APPLICATION NO.	FILING DATE	FIRST NAMED INVENTOR	ATTORNEY DOCKET NO.	CONFIRMATION NO.
10/596,812	07/19/2007	Akihiro Bungo	20154/0205051-US0	1756
7278	7590	09/28/2009	EXAMINER	
DARBY & DARBY P.C. P.O. BOX 770 Church Street Station New York, NY 10008-0770			DINH, TRINH VO	
			ART UNIT	PAPER NUMBER
			2821	
			MAIL DATE	DELIVERY MODE
			09/28/2009	PAPER

Office Action Summary	Application No. 10/596,812	Applicant(s) BUNGO ET AL.	
	Examiner Trinh Vo Dinh	Art Unit 2821

DETAILED ACTION

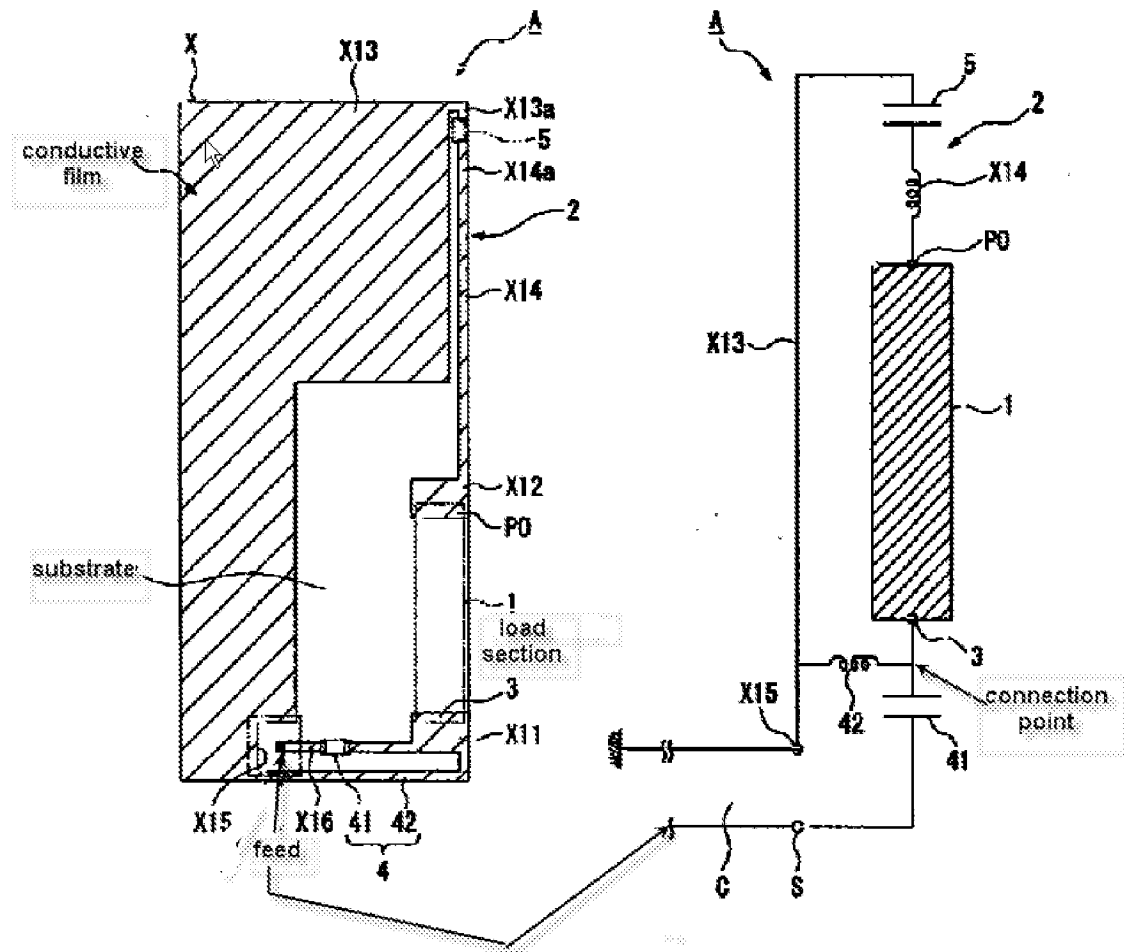
5. Claims 1-3, 5 and 7-8 are rejected under 35 U.S.C. 102(b) as being anticipated by Yokoshima, Takao (JP 2002 271123 of record).

Respecting claim 1, Yokoshima discloses, in Figs. 1-2, 4 or the below drawing, a substrate; a conductor film which is disposed on a portion of the substrate; a feed point disposed on the substrate; a loading section (1) disposed on the substrate and constructed with a line-shaped conductor pattern (12 in Fig. 4) which is formed in a longitudinal direction of an elementary body made of a dielectric material; and an inductor section (42) which connects one end (3) of the conductor pattern to the conductive film, and wherein the feed point which feeds a current to a connection point of the one end of the conductor pattern and the inductor section, and wherein a longitudinal direction of the loading section is arranged to be parallel to an edge side of the conductor film.

Respecting claim 2, Yokoshima discloses a capacitor section (41) being connected between the connection point and the feed section.

Respecting claim 5, Yokoshima inherently discloses the capacitor section (41) including a capacitor section which is constructed with a pair of planar electrodes formed on the elementary body to face each other (*referred to a definition of a basic capacitor that is made up of two conductors (reads on electrodes) separated by an insulator, or dielectric (read on a capacitor section). The dielectric can be made of paper, plastic, mica, ceramic, glass, a vacuum or nearly any other nonconductive material. Some capacitors are called electrolytics, meaning*

Respecting claims 7-8, Yokoshima discloses a multiple-resonance capacitor section (5, 4, 41; E12, E22) is equivalently serially connected between two different points of the conductor pattern (12), and the conductor pattern (E, 12 in Fig. 4) is wound around the elementary body in a longitudinal direction thereof in a helical shape.
